**Subject: Data Response #1 through #9, Air Quality Amendment 1
Ivanpah Solar Electric Generation System 07-AFC-5C**

Air Amendment 1, Ivanpah Solar Electric Generating System

Responses to Data Request #1 through 9 Received from

Christopher Dennis, CEC, Sacramento, CA

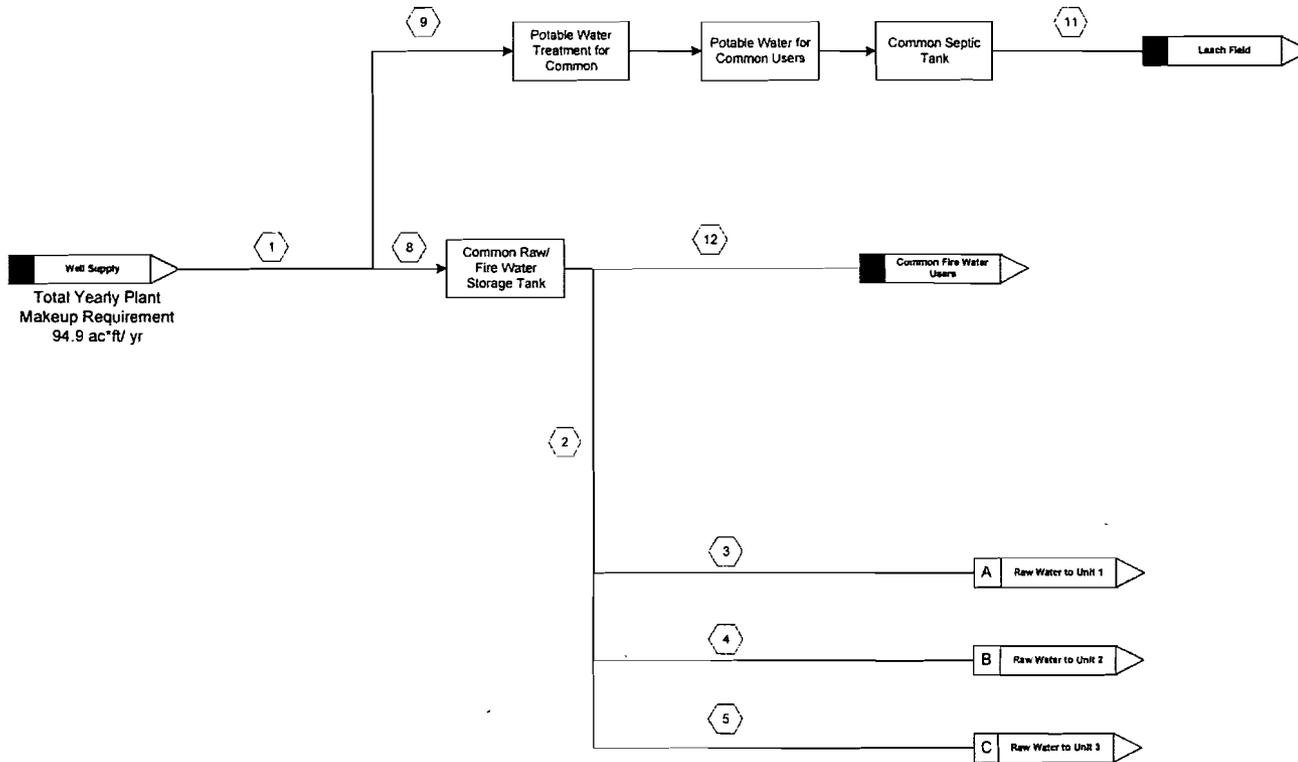
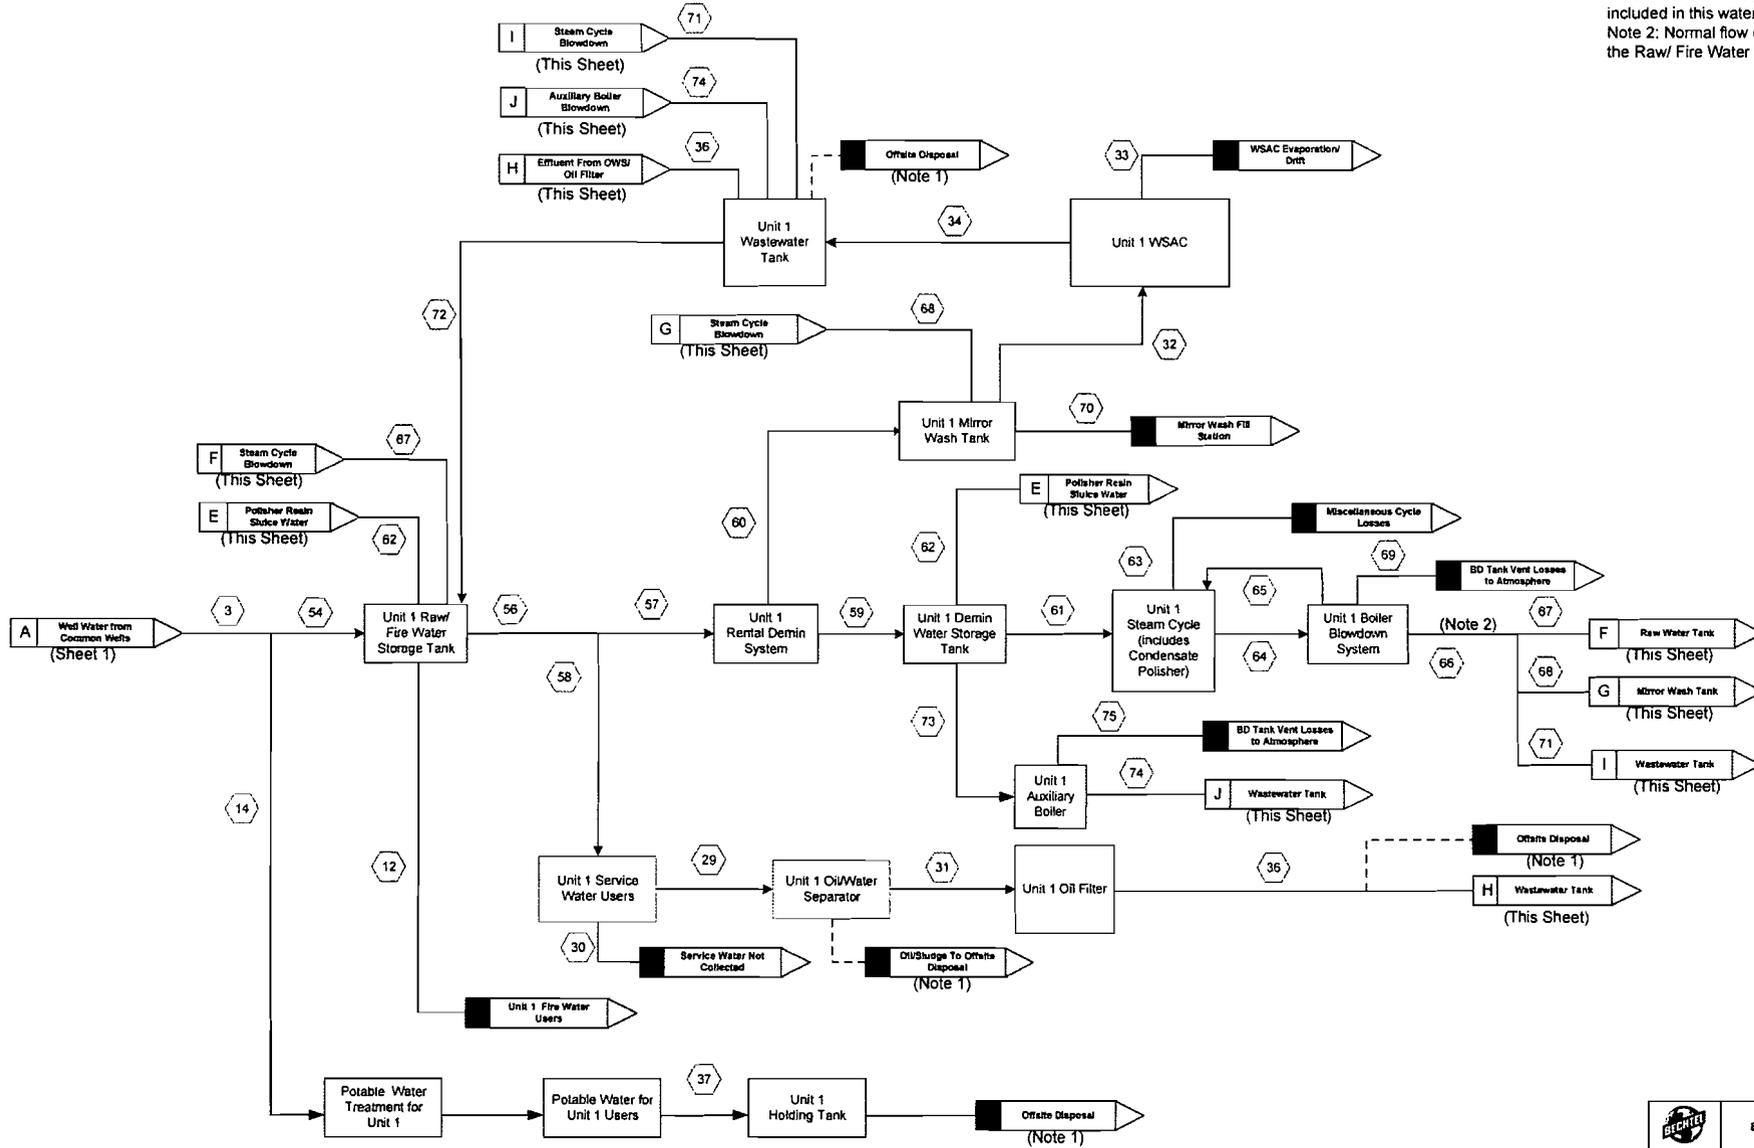
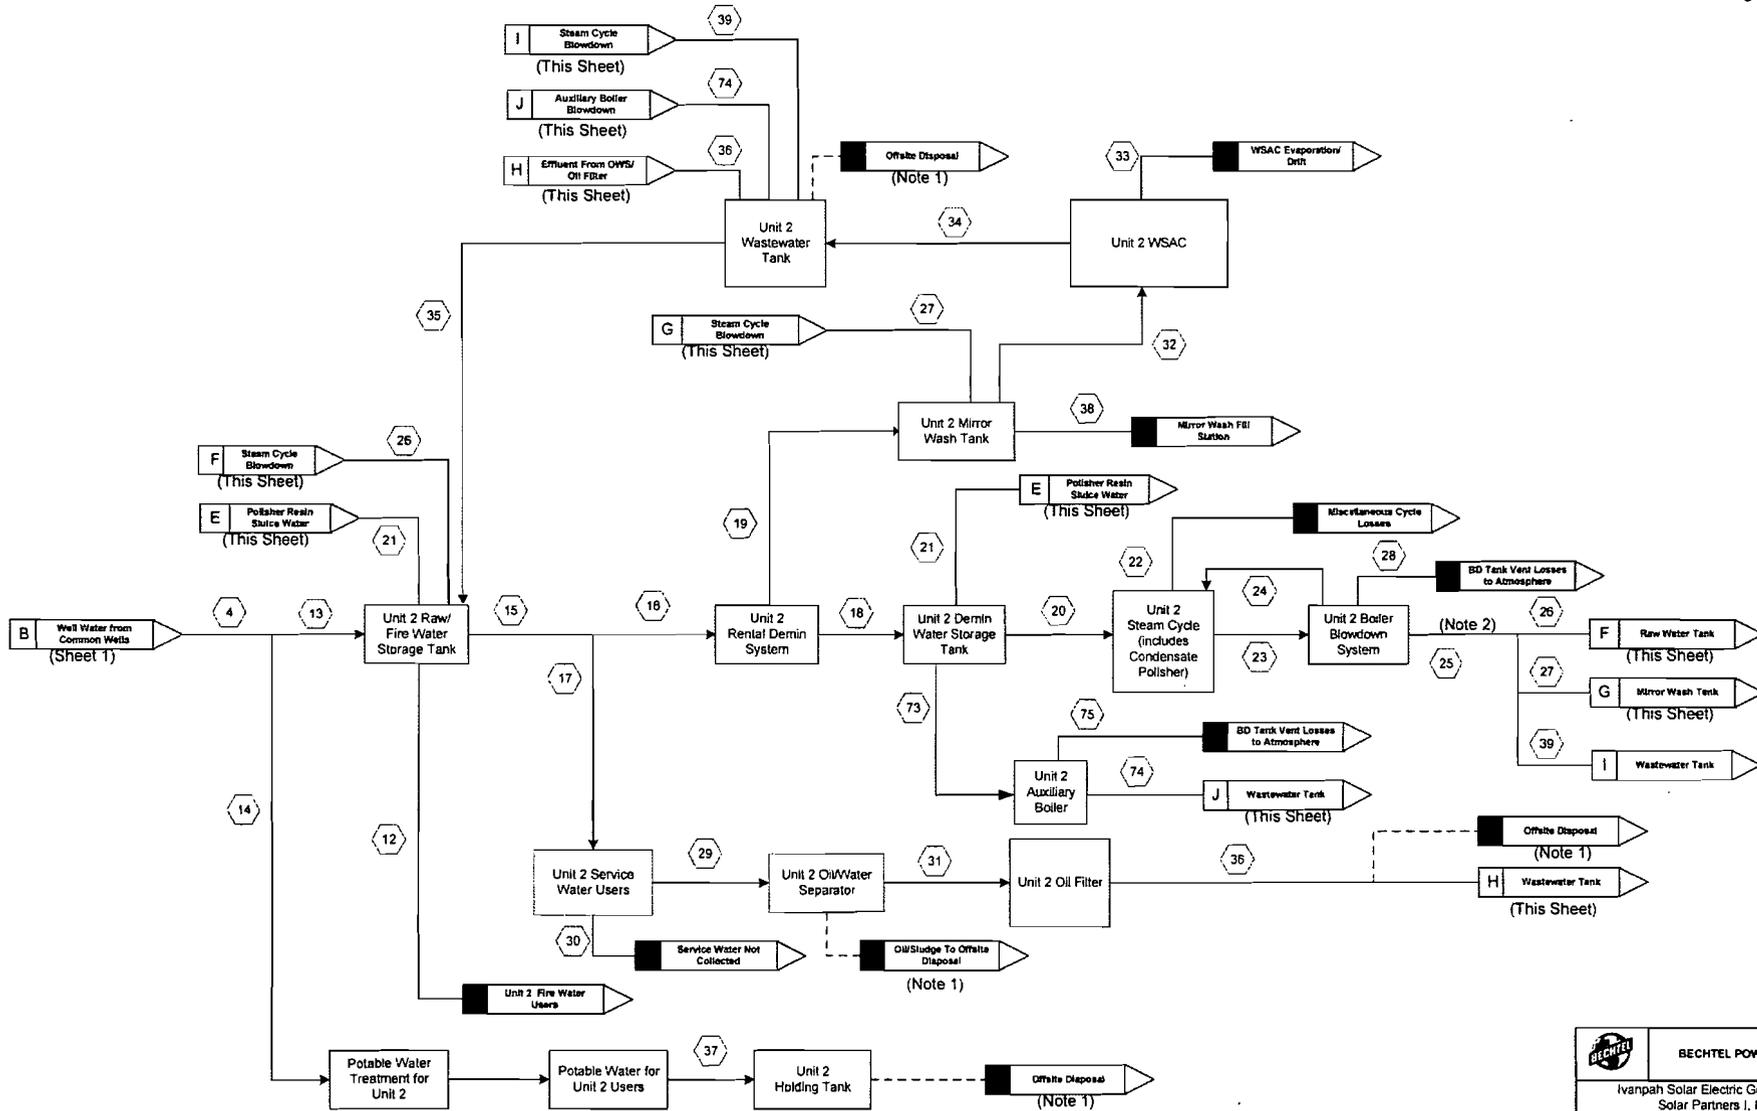
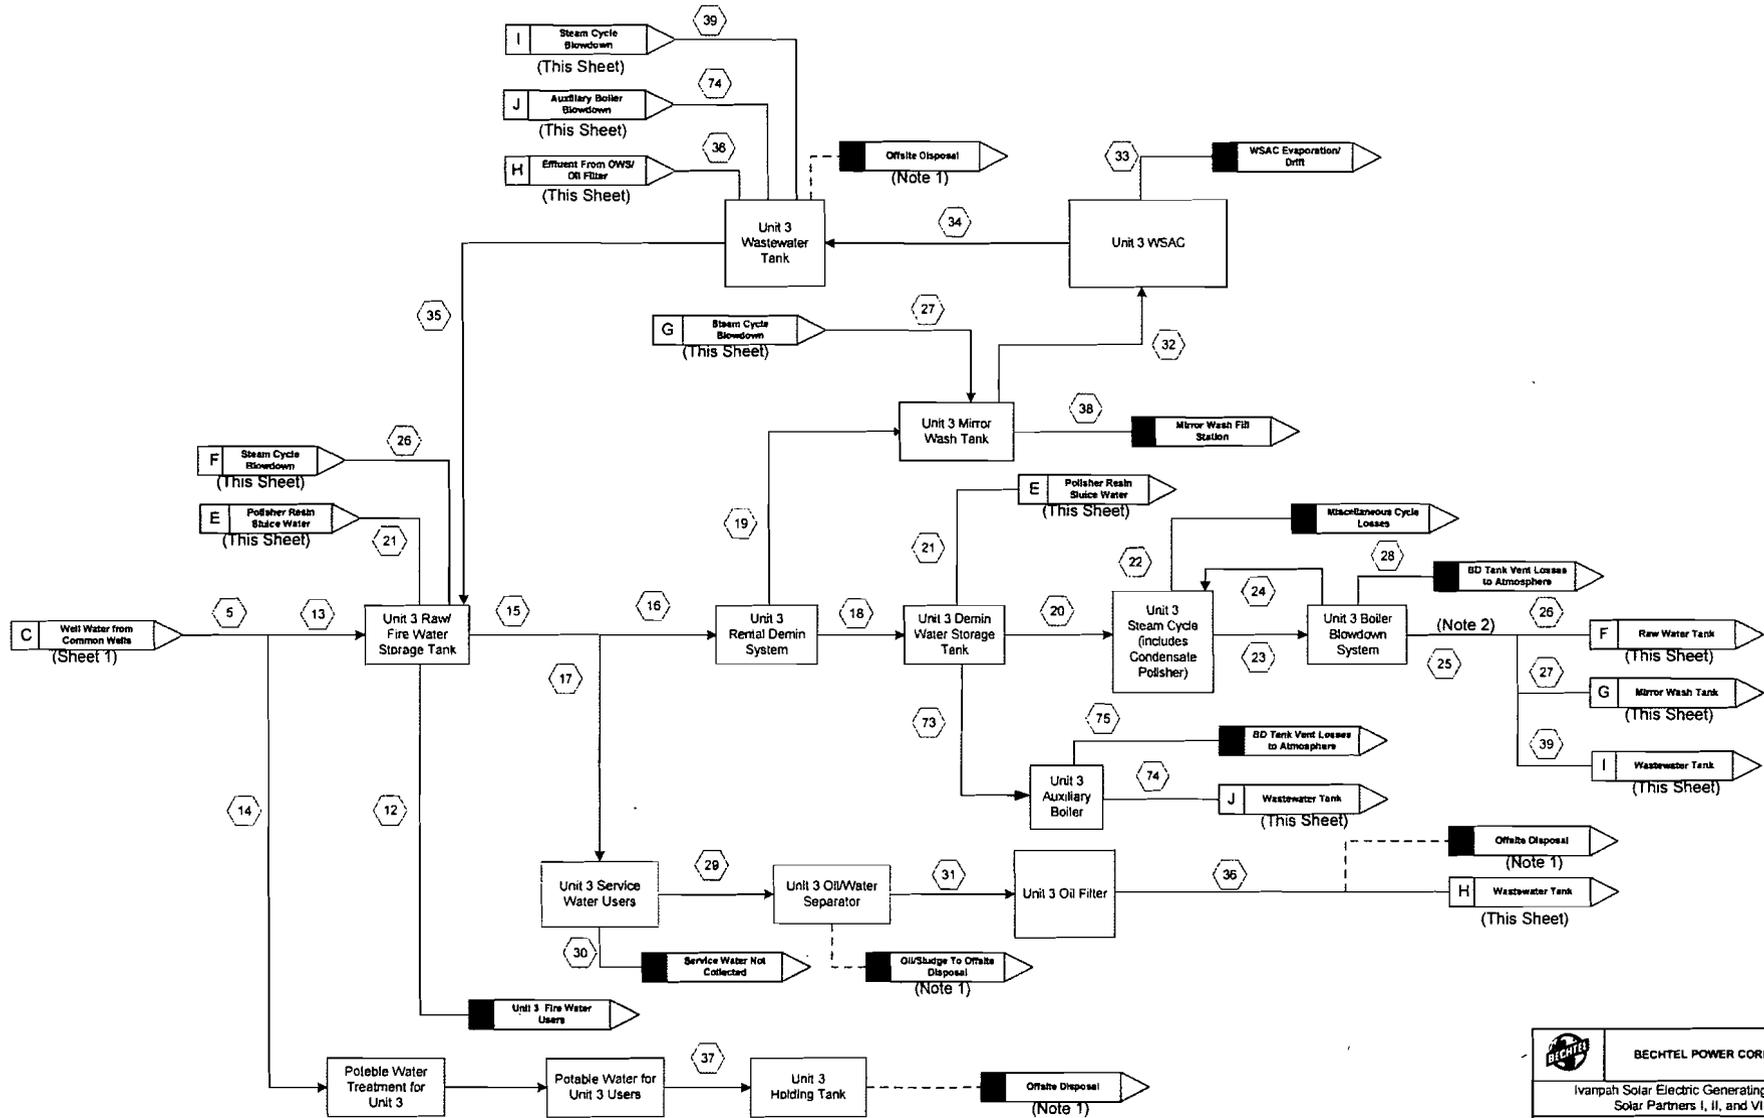
7. Please provide information indicating whether each WetSAC system will use up to six acre-feet of groundwater or all three WetSAC systems together will use up to six acre-feet of groundwater.

9. Please provide water mass balance and heat balance diagrams for both average and maximum flow rates that include all process and/or ancillary water supplies and wastewater streams.

To gain an understanding of how the WSAC fits in the overall plant water system, refer to Attachment 2 for the water balance diagram (Bechtel drawing 25542-000-M5-YA-00001, rev 000). Figure 2 shows 72 total water balance cases at ambient dry bulb temperatures ranging from 53.6°F and lower through 111.2°F and higher, and varying operating conditions including: 25% load, 50% load, 75% load, 100% load (at guaranteed heat rate), power boosting mode, and 100% load (at guaranteed output). A conceptual sketch of the systems is included below.

The water balance diagram in Attachment 2, page 8, table B “Demineralized Water Consumption” shows the maximum makeup water to the WSAC is six (6) acre-feet per year for each unit, or a total of eighteen (18) acre-feet per year.

The water mass balance is shown for all three units in Attachment 2. There are 72 total water balance cases at ambient dry bulb temperatures ranging from 53.6°F and lower through 111.2°F and higher, and varying operating conditions including: 25% load, 50%

The makeup water to the WSAC does not vary with load, only with ambient temperature. For example, cases 49 through 54 are at ambient dry bulb temperatures of between 100°F and 104.9°F. Flow for several streams increases as load increases from 25% to full load (e.g., steam cycle makeup and blowdown).
